COA-0134-2019

401 E WHITAKER MILL RD
 RALEIGH HISTORIC
 LANDMARK (R-10)

Nature of Project:
 Remove and reconstruct cupola using synthetic material;
 Alter exterior stairs on east and north facades

APPLICATION FOR A CERTIFICATE OF APPROPRIATENESS – STAFF REPORT

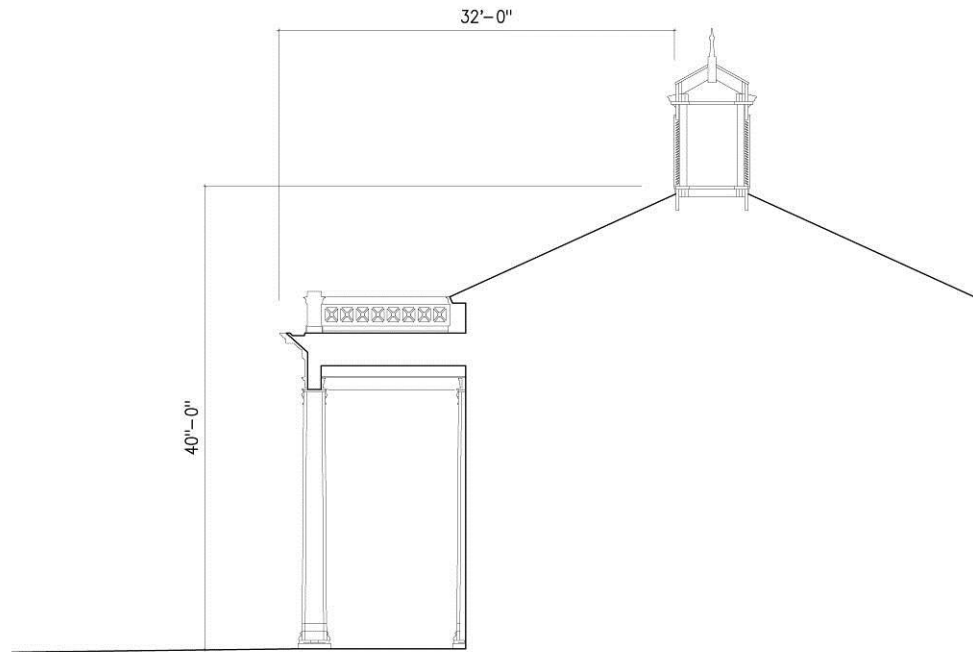
- 3* The application proposes the removal of the existing cupola and replacement with a reproduced version using synthetic materials.
- 4* Due to the height of the cupola, 40 feet above the ground, and the lack of access to the roof, it is difficult to provide an accurate assessment of the cupola’s current condition.

- 5* Photographic evidence provided by the applicant shows evidence of peeling paint, wood rot, and joint separation. The photographs were taken prior to 2015, thus the current condition is unknown.

- 6* No information is provided to indicate that the cupola in its entirety is irreparable and that the individual components require replacement.
- 7* The application includes the following information and statements to support the assertion that repairing or replacing the cupola in-kind would be technically infeasible:

1915 Postcard,
original design

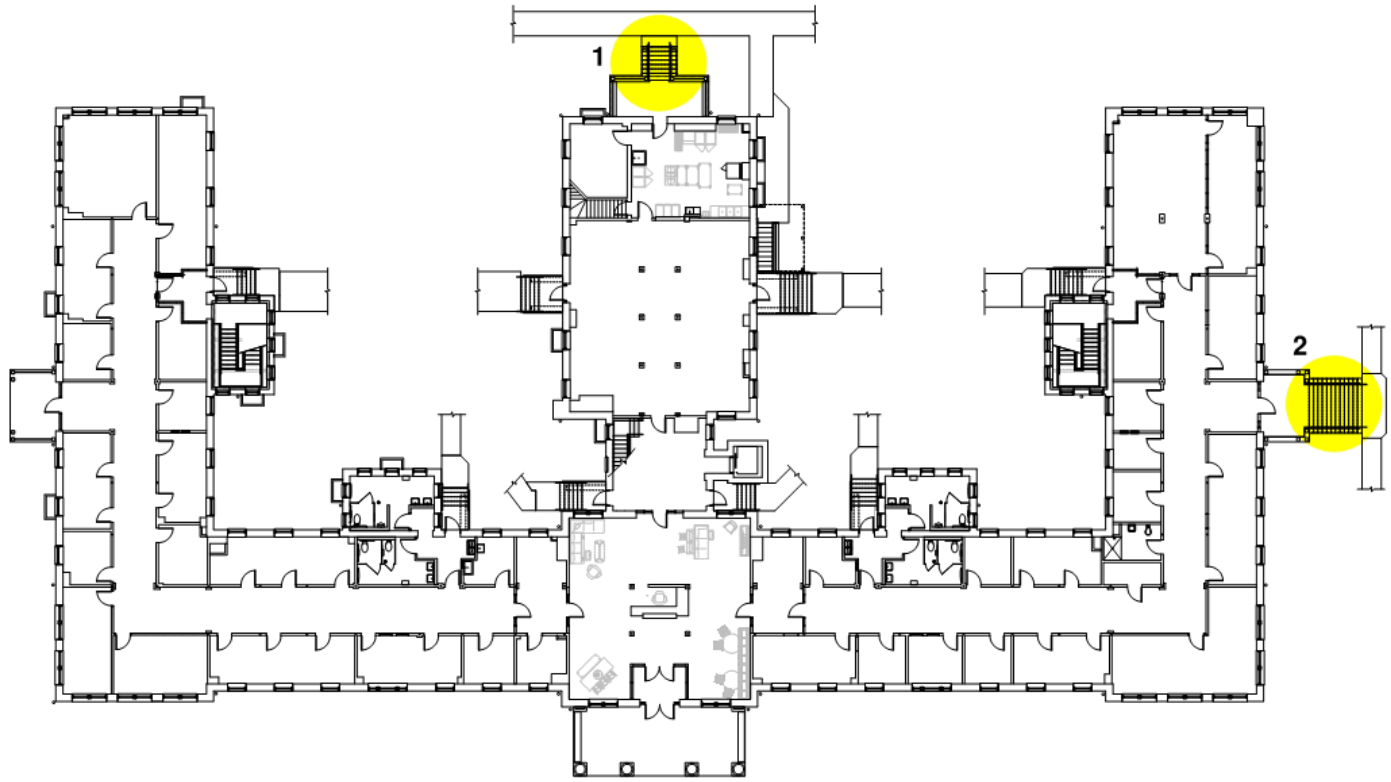
- 9* The application indicates that the cupola was most recently “renovated” in 2015. A description of the extent of work completed was not provided.
- 10* The application includes photographic evidence showing that the cupola has been altered over time and was changed to its current simplified design after the Landmark’s period of significance (1913-1914). The original cupola was destroyed by fire in 1943. When the roof and cupola were rebuilt, the design was changed substantially to its current appearance.

11* The application asserts that “The current Cupola is simplified and it doesn’t reflect the historical significance of the original style.”

Exterior stair 1

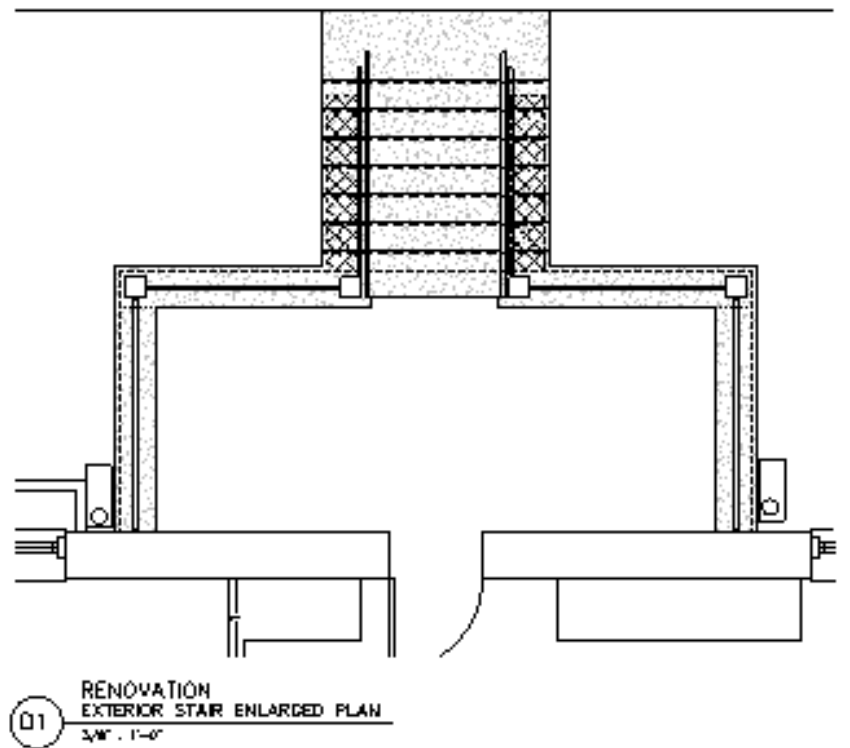
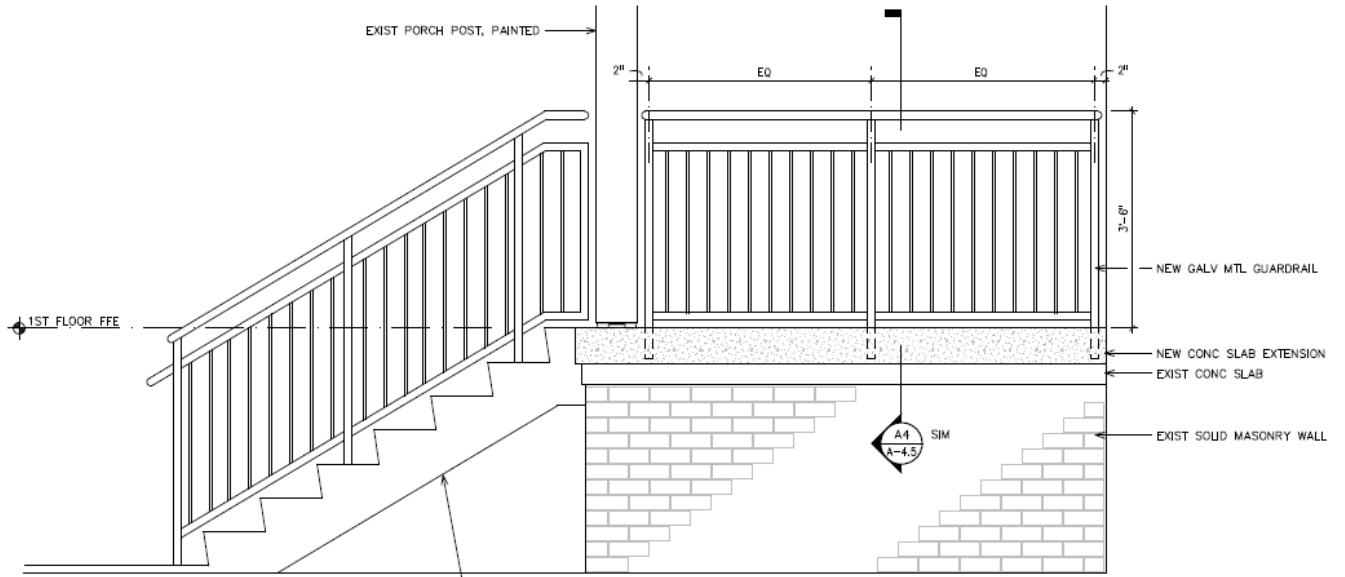
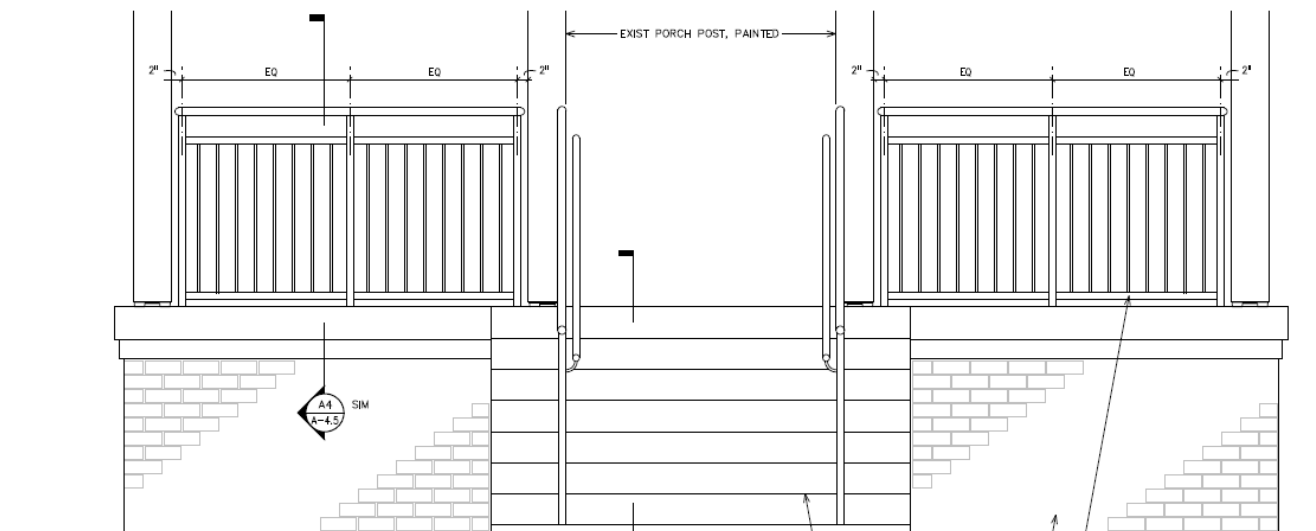
- 4* The proposed changes include the installation of new handrails and alterations to the steps to improve uniformity in size and dimension.
- 5* The alterations are proposed to bring the building into current code compliance and improve accessibility.

- 6* The alterations to the stairs also include the removal of the existing cheek walls. The necessity of the removal of the cheek walls is unclear, as the drawings appear to indicate that the width and handrail location will be remaining the same.
